ADDENDUM 01

USM Brooks Center eSports Improvements

Date: October 11, 2024

USM - Brooks Center eSports Improvements

A121

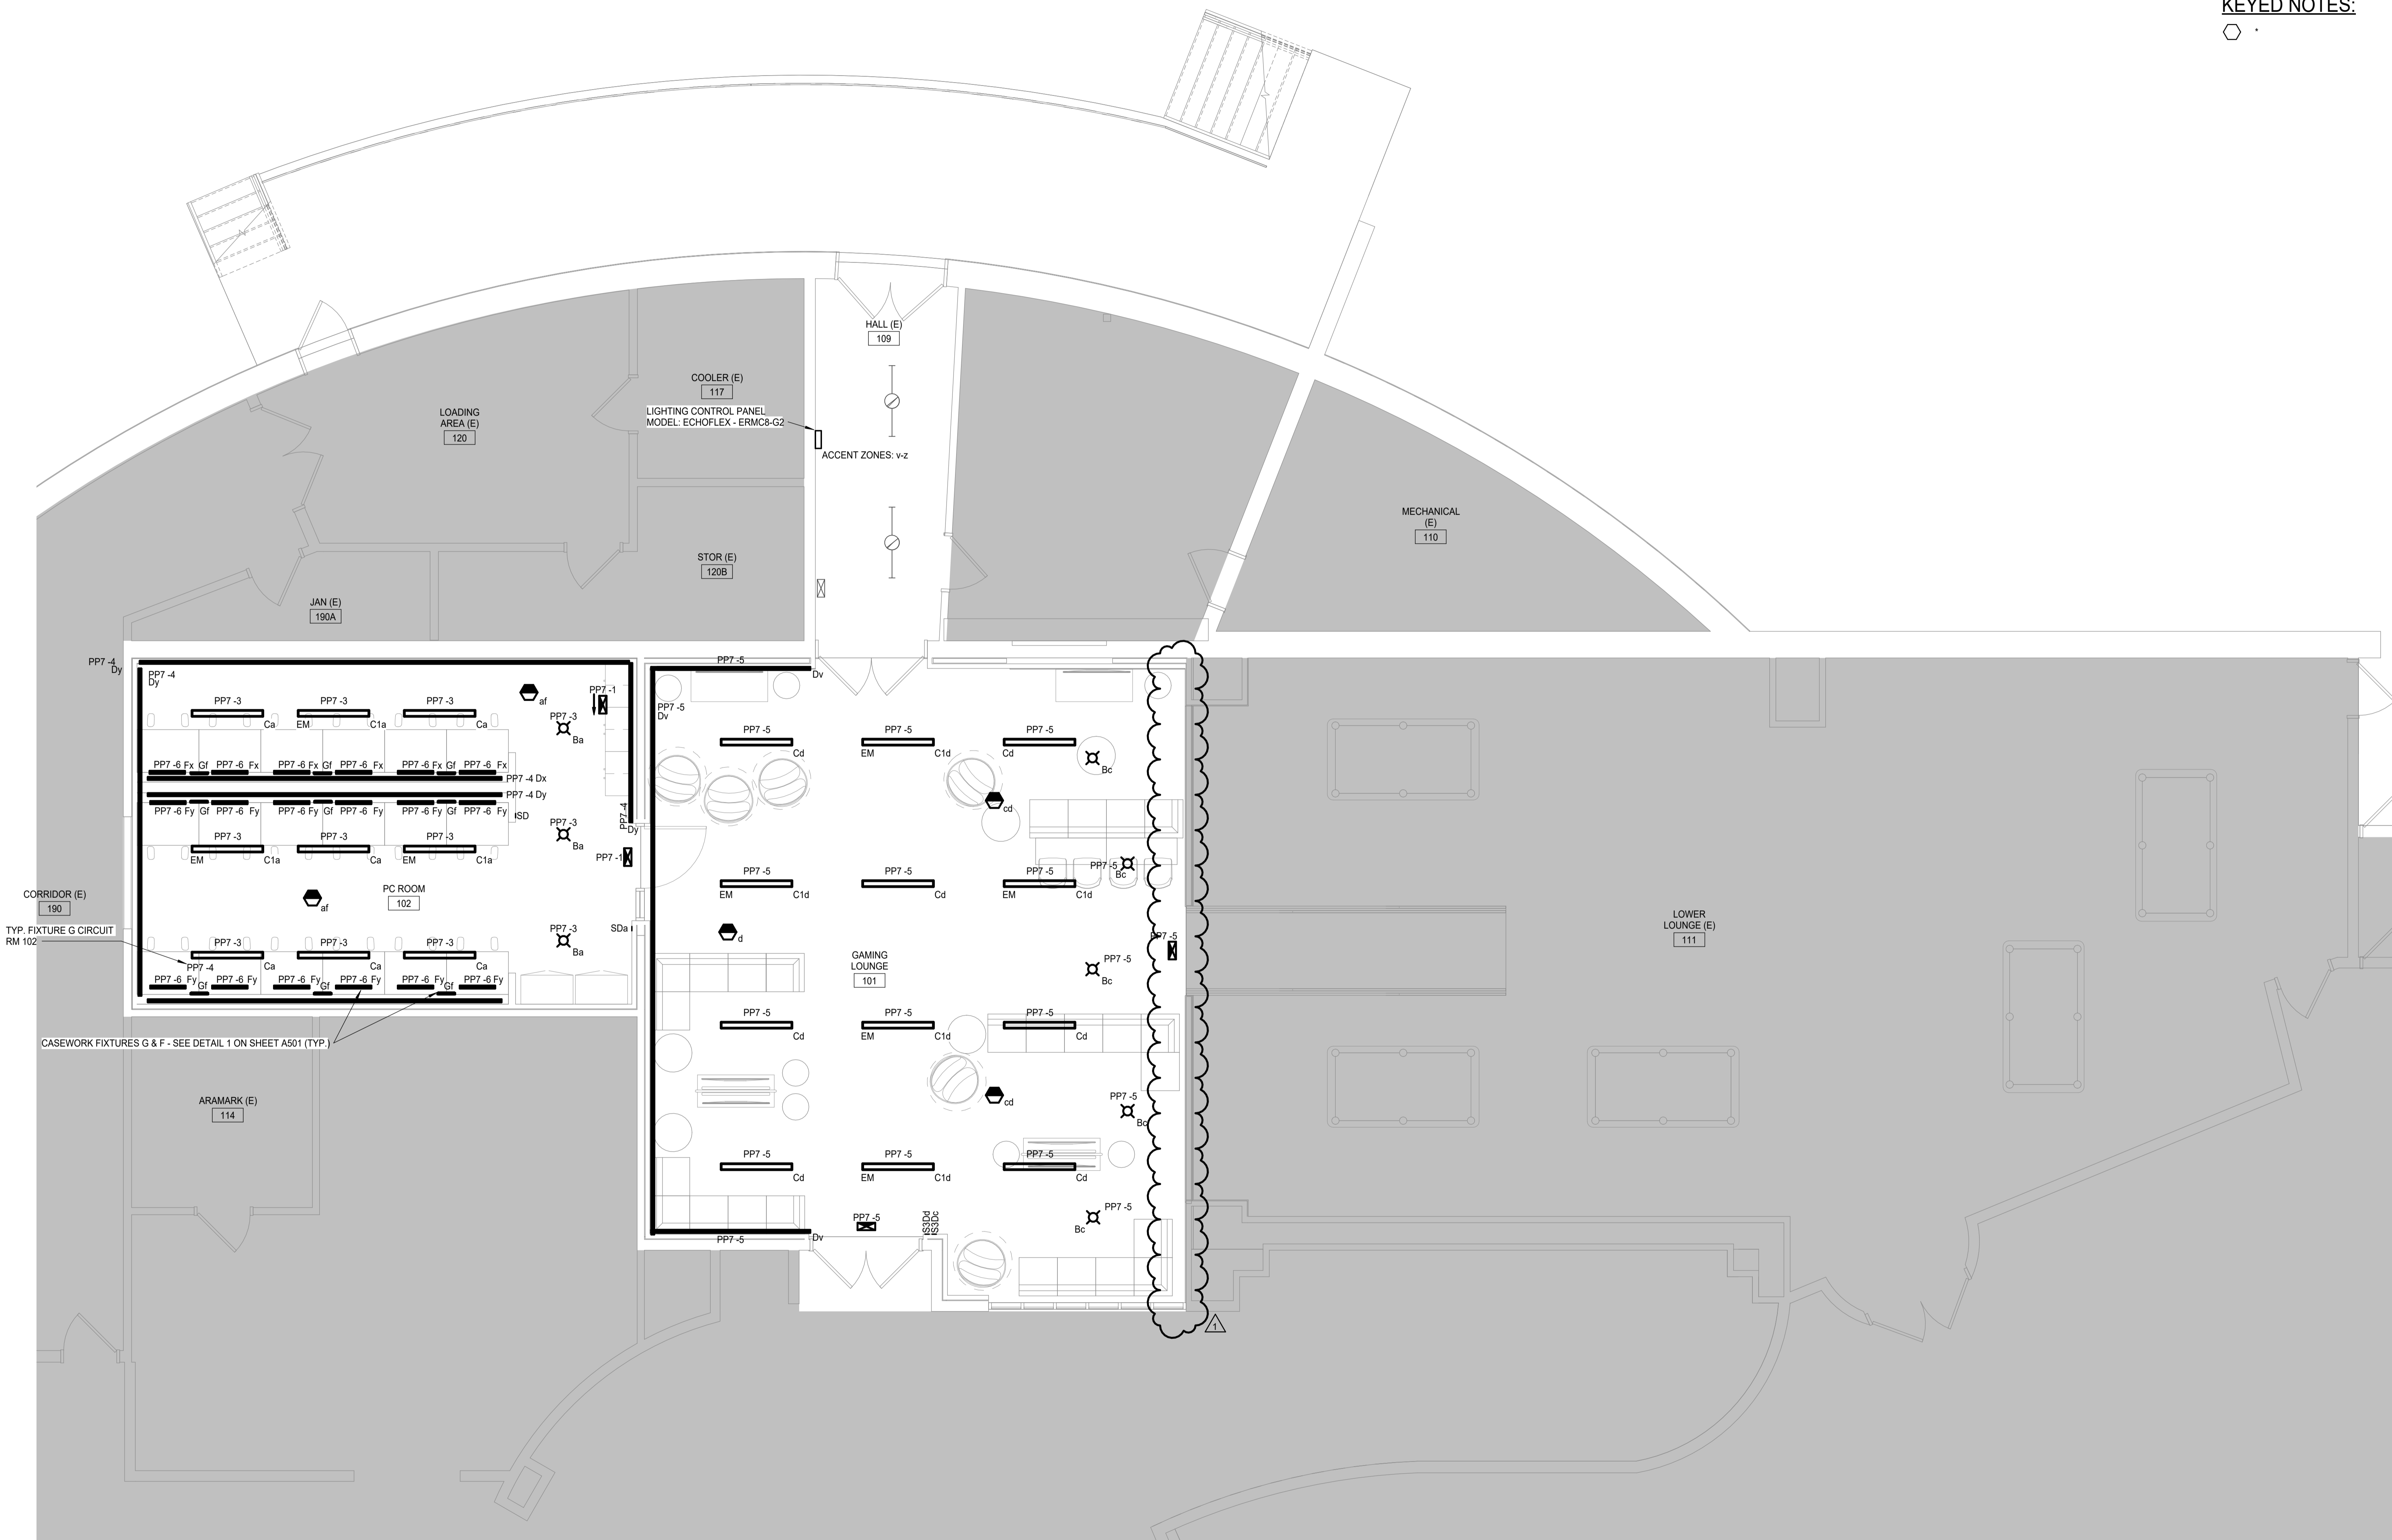
A121 – Relocate exit signs to align with electrical drawings

GL100

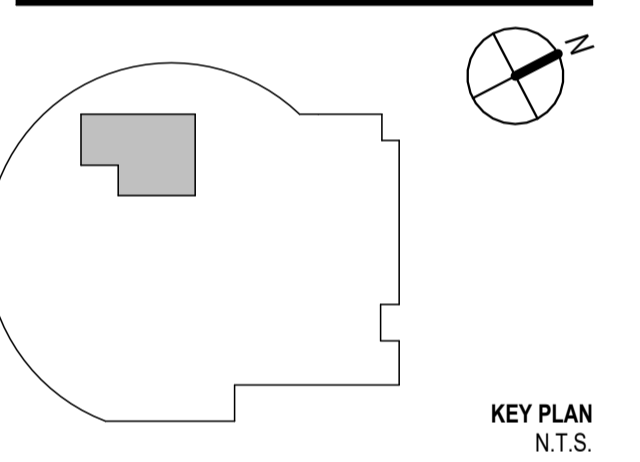
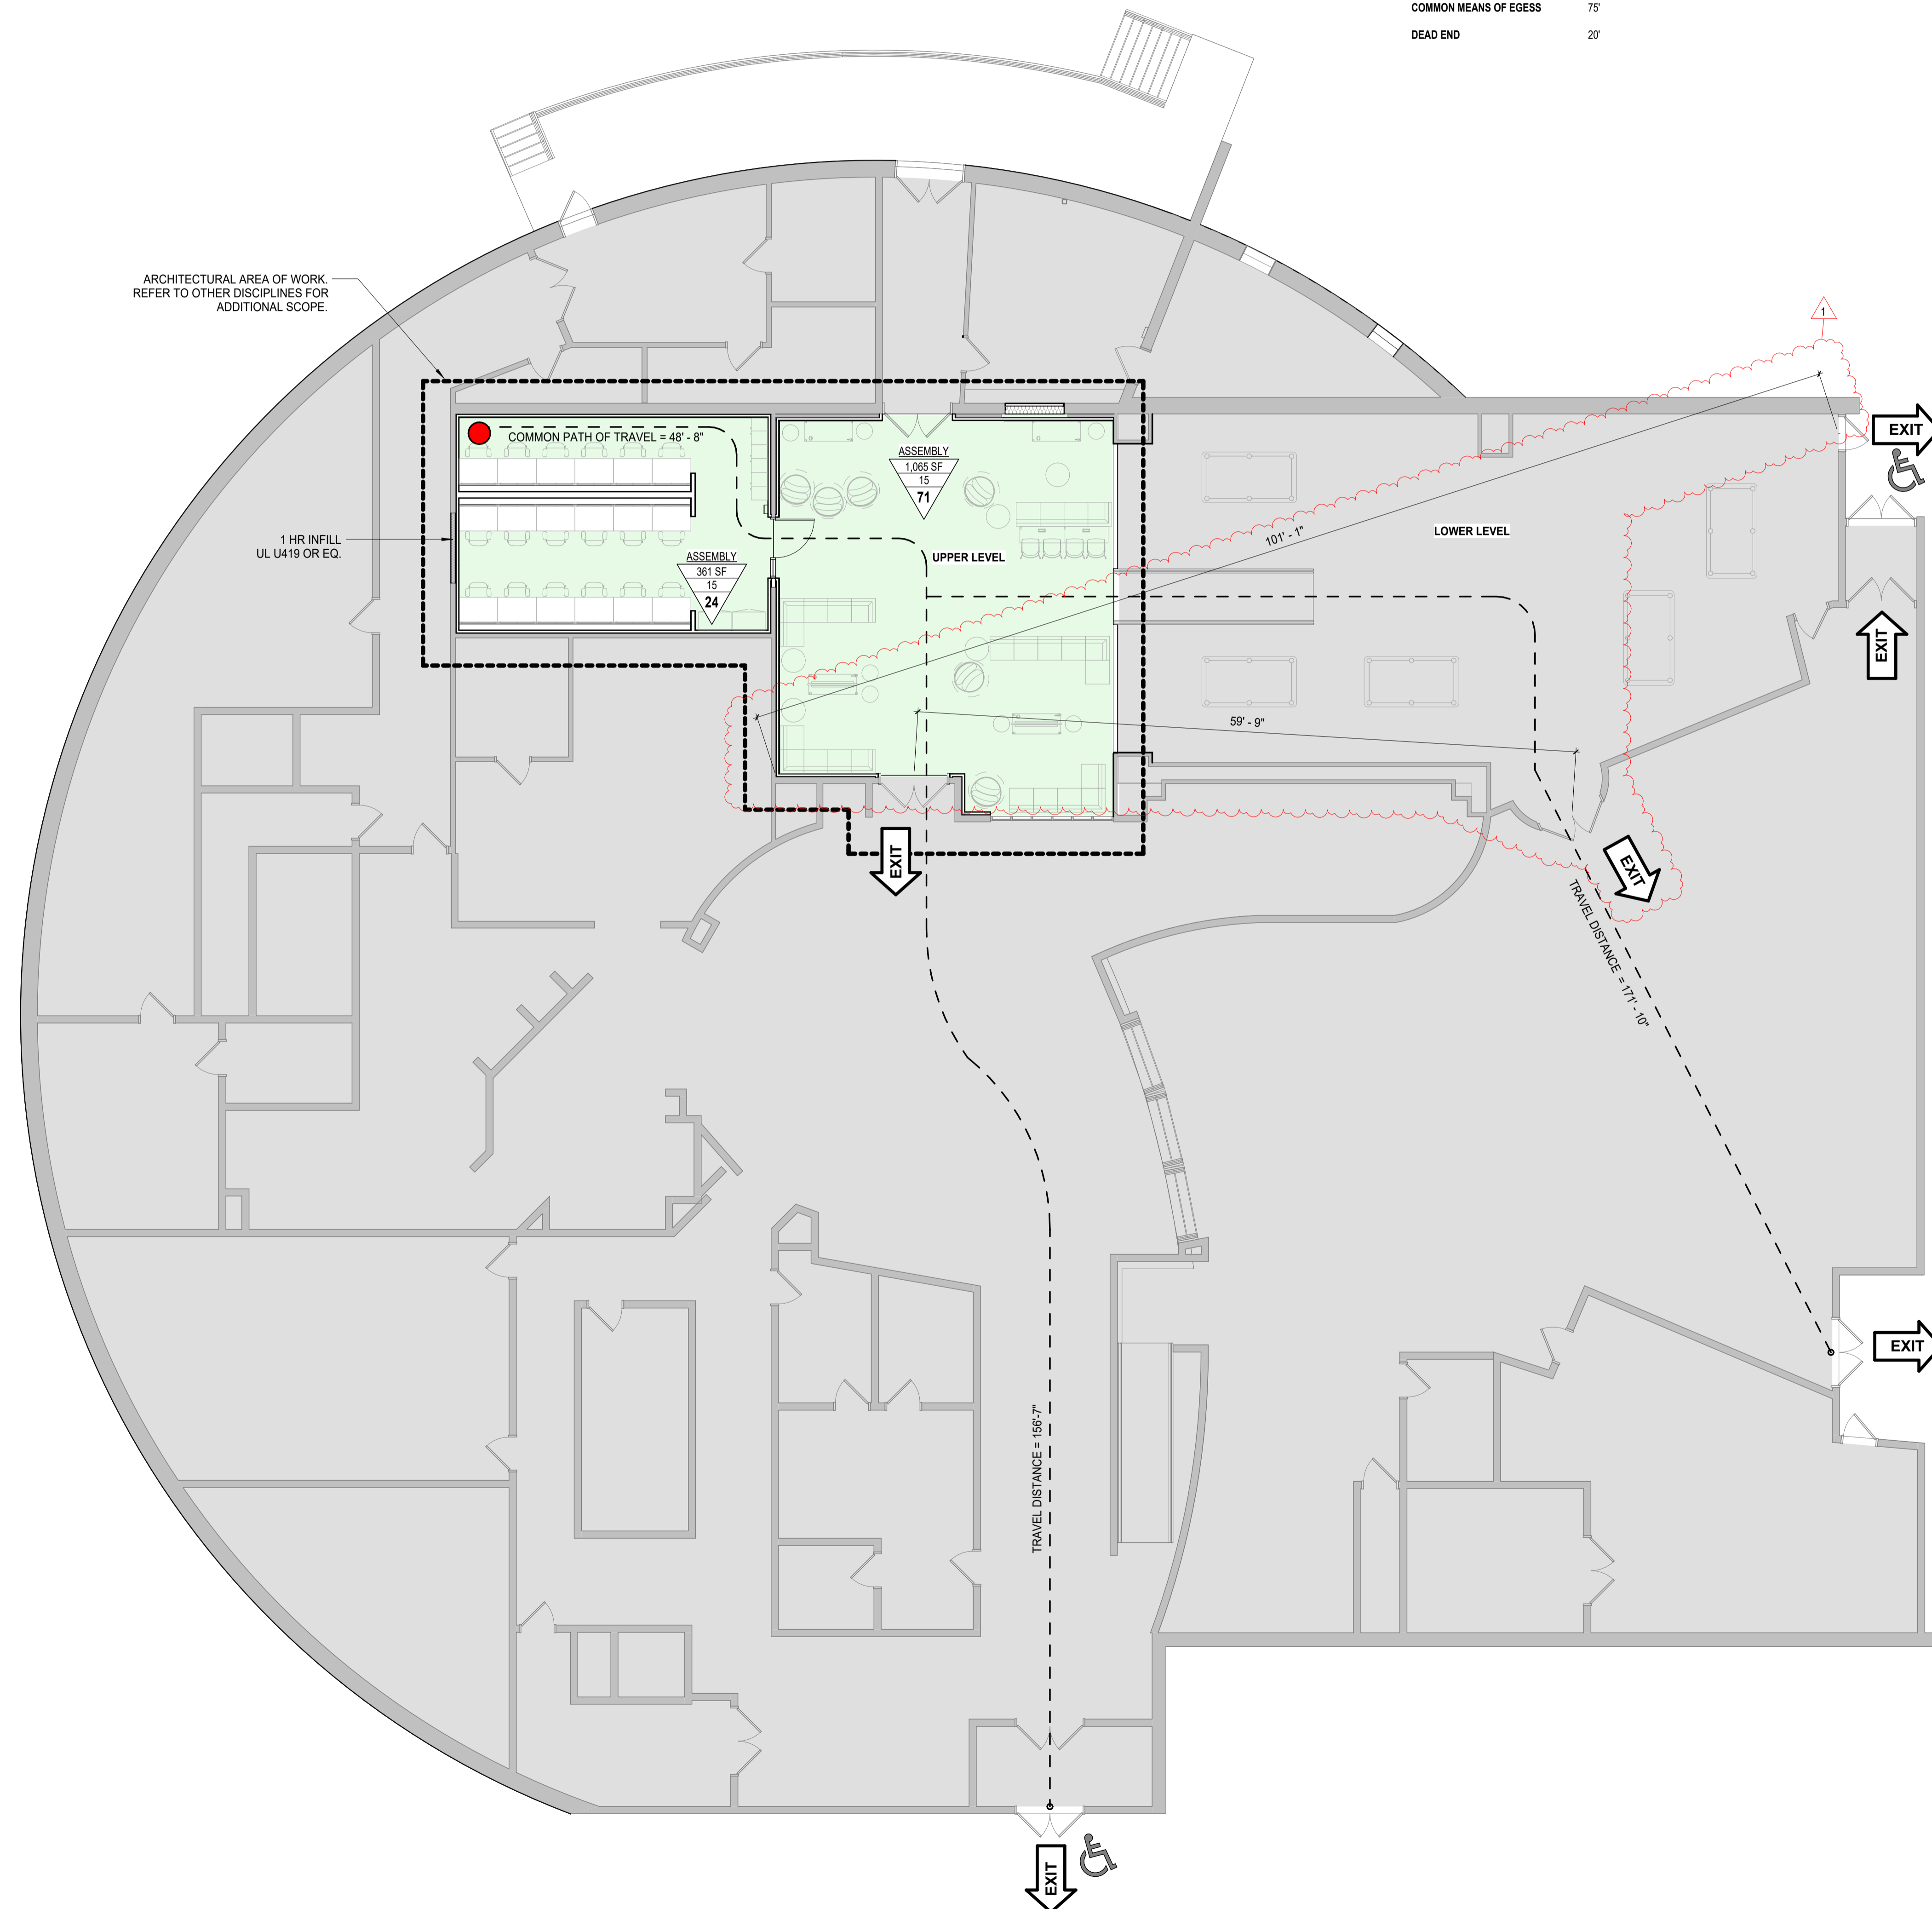
GL101 – Add dimensions showing existing egress door remoteness per SFMO request

M-651

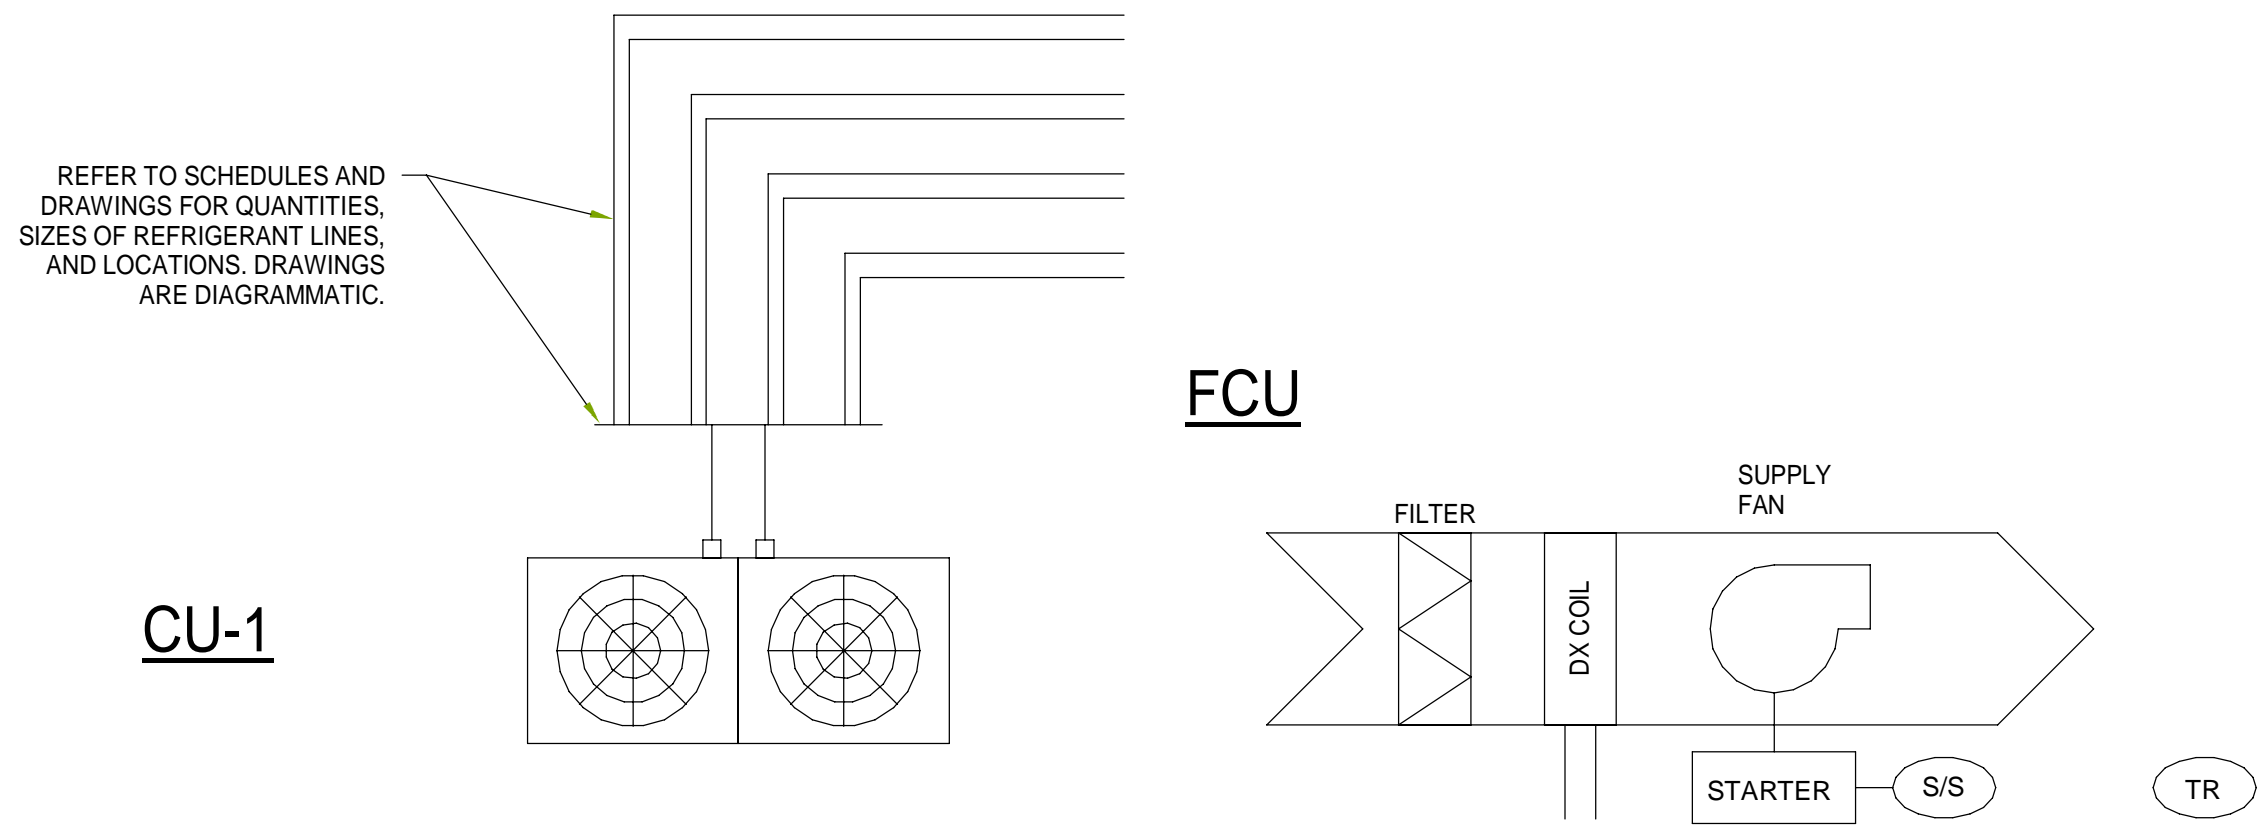
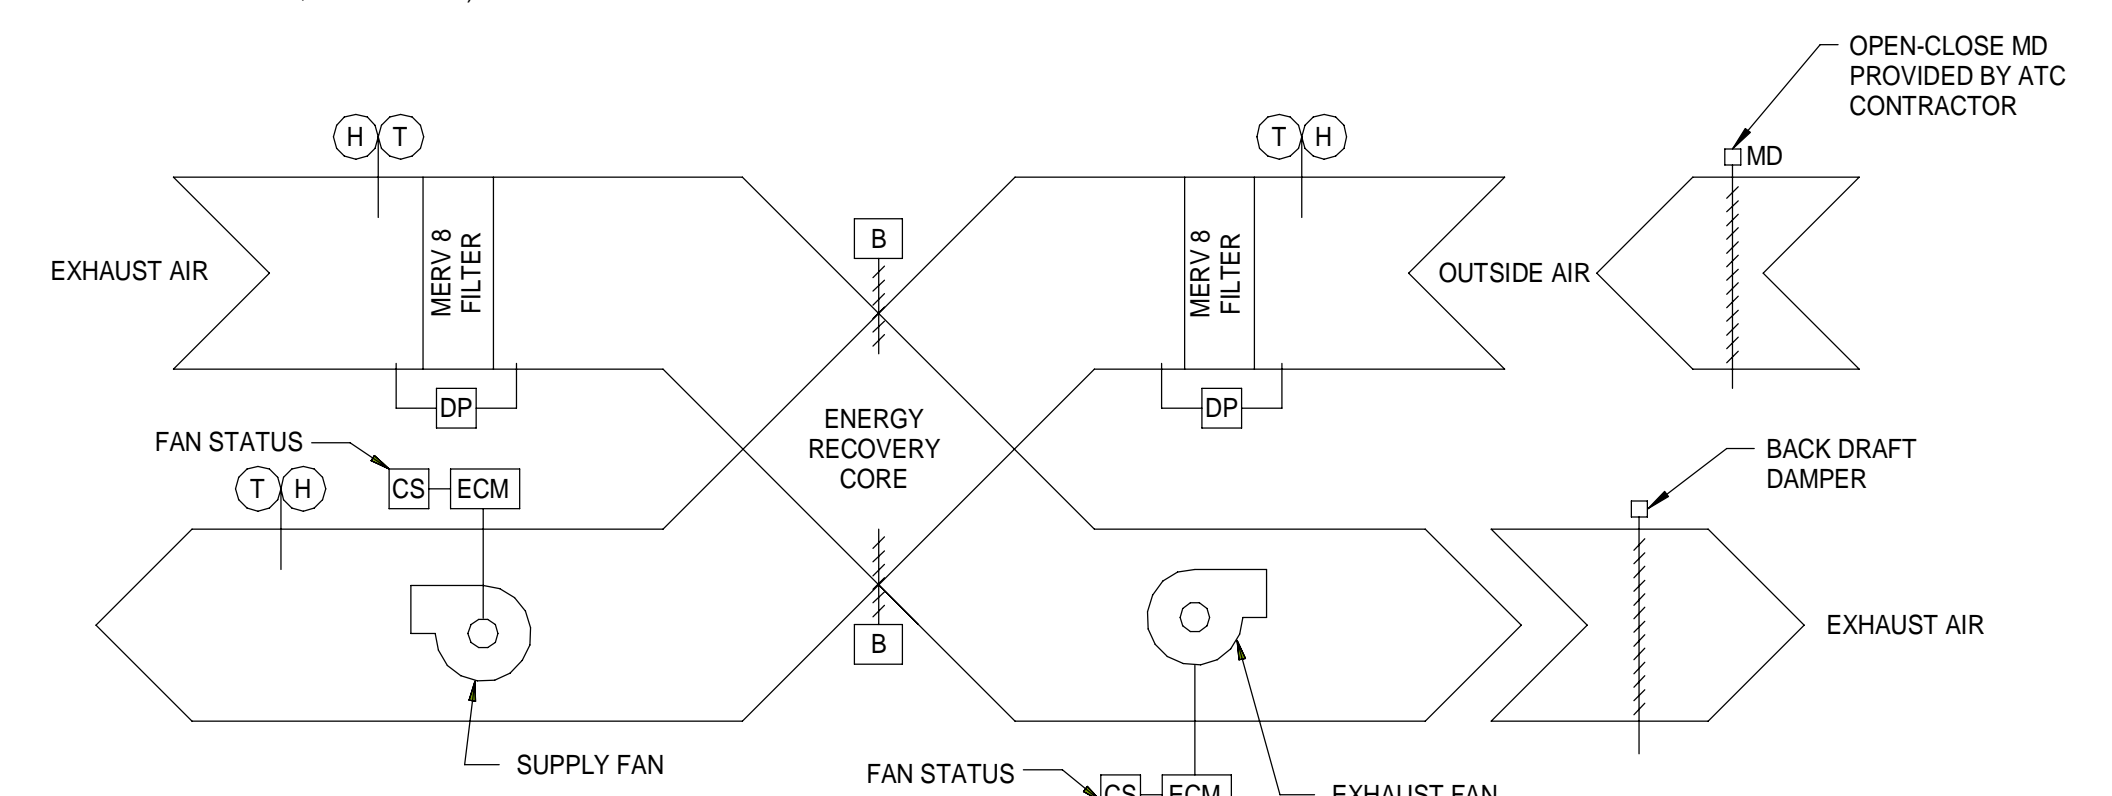
M-651 – Added electric duct heater sequence of operations. Adjusted VRF system sequence to reflect heat pump system instead of heat recovery. Adjusted VRF piping diagram to reflect new equipment selections and piping layout.
